**From:** Joni Brewer <jonibrewer11@gmail.com>  
**Sent:** Friday, January 28, 2022 7:19 AM  
**To:** Olivia Dias  
**Cc:** glennbaly12345@gmail.com; hughes.m@comcast.net  
**Subject:** Re: Devon Ave Subdivision

Case No. SUB21-01MOD1

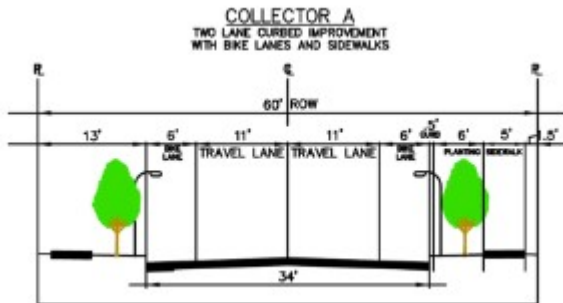
What are the city standards for Lone Oak and Devon?

Lone Oak is a Collector, the standard is generally as shown below. The connection from Sahalee Drive to the south property line would meet this standard on either side of the street. The remainder of the street from the subject property to Rees Hill (or to a stopping location as proposed by the applicant), since off-site, is considered a 'linking street' (SRC200.055). This street would be a 34-ft wide turnpike improvement. Turnpike meant there is only two travel lanes, no sidewalk or street trees. Because of proportionality considerations, City regulations do not generally require developers to construct off-site street improvements, except for linking streets.
